Access Compliance Report

Public Rights-of-Way

(Curb Ramps)

Intersection ID: 52933	Main Street: EMORY_OAK_DR	Cross Street: WILLOW_OAK_POND_LN	Location: NW
ADA ID: 2B225ABC2FDB	Ramp Type: Perp	Initial Pass/Fail: Fail	Overall Compliance: No
Severity Score: 10			
Codes/Mitigation Info/Possible Solution		Field Measurements/Component Compliance

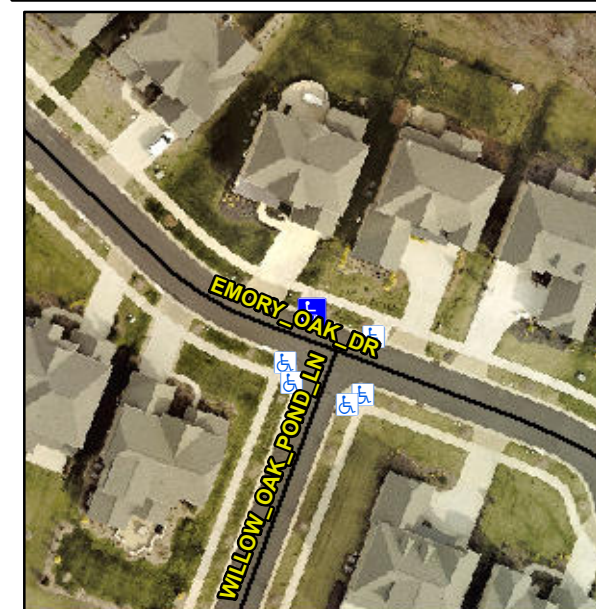
Not Found, R304.5.1, R304.5.3

Compliance	Description	Data	Compliance	Description	Data
N/A	Ramp Length (in)	97.0	Yes	Ramp Slope (%)	6.2
No	Ramp Width (in)	47.0	No	Ramp XSlope (%)	2.5
N/A	Flare Type LT	N/A	N/A	Flare Type RT	N/A
N/A	Flare Slope LT (%)	N/A	N/A	Flare Slope RT (%)	N/A
N/A	Flare Traversable LT?	N/A	N/A	Flare Traversable RT?	N/A
N/A	Landing Length (in)	N/A	N/A	DWS Provided?	N/A
N/A	Landing Width (in)	N/A	N/A	DWS Contrast?	N/A
N/A	Landing Slope (%)	N/A	N/A	DWS Length (in)	N/A
N/A	Landing X Slope (%)	N/A	N/A	DWS Full Width?	N/A
N/A	Landing Curb? (Y/N)	N/A	N/A	DWS Offset (in)	N/A
N/A	Shared Landing?	N/A			
N/A	Gutter Ponding?	N/A	N/A	Gutter Slope (%)	N/A
N/A	Gutter Lip Ht (in)	N/A	N/A	Gutter X Slope (%)	N/A
N/A	Painted X Walk1?	No	N/A	Painted X Walk2?	N/A
	X Walk 1 Direction	To S		X Walk 2 Direction	N/A
N/A	X Walk 1 Width (in)	N/A	N/A	X Walk 2 Width (in)	N/A
	X Walk 1 Slope (%)	3.4		X Walk 2 Slope (%)	N/A
	X Walk 1 X Slope (%)	2.3		X Walk 2 X Slope (%)	N/A

Remove & Replace Entire Ramp.
